# STAFF RECOMMENDATION

NCPC File No. MP 194

## NEBRASKA AVENUE COMPLEX DRAFT MASTER PLAN

Submitted by the General Services Administration

**Draft Master Plan Access Plan**

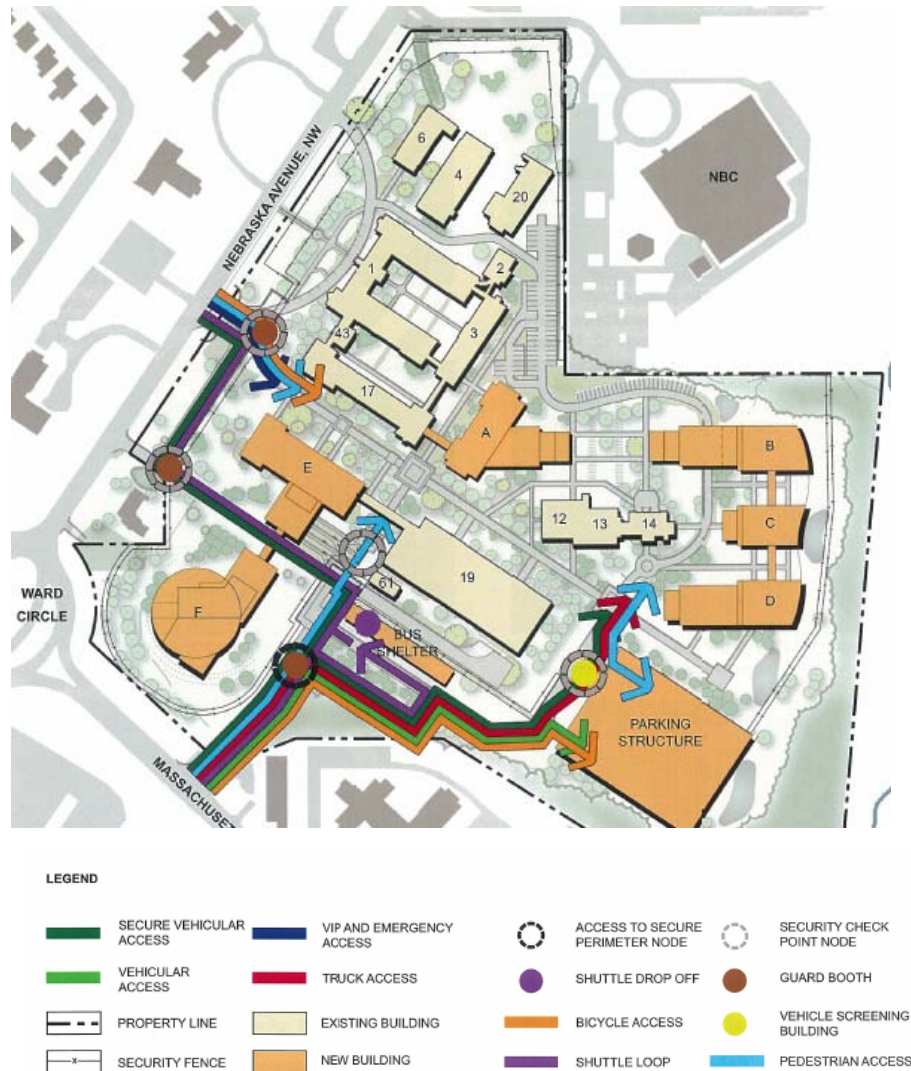
Currently, the draft Master Plan has pedestrian access to the NAC at two locations, one on Nebraska Avenue, and one on Massachusetts Avenue. Given that the pedestrian access point along Nebraska Avenue is over 600 feet from the beginning of the NAC boundary, staff encourages GSA for the potential for pedestrian and bicycle access further north on Nebraska Avenue, NW than what is proposed to allow for greater accessibility to Tenleytown and the Metrorail station.

Regarding vehicular access to the site, currently the draft Master Plan proposes vehicular access off of Massachusetts Avenue, with secure, VIP, and emergency access off of Nebraska Avenue. We recommend GSA evaluate the use of Nebraska Avenue, NW, in conjunction with access from Massachusetts Avenue, NW, for employee and visitor access to the parking garage in order to alleviate pressures on Massachusetts Avenue.
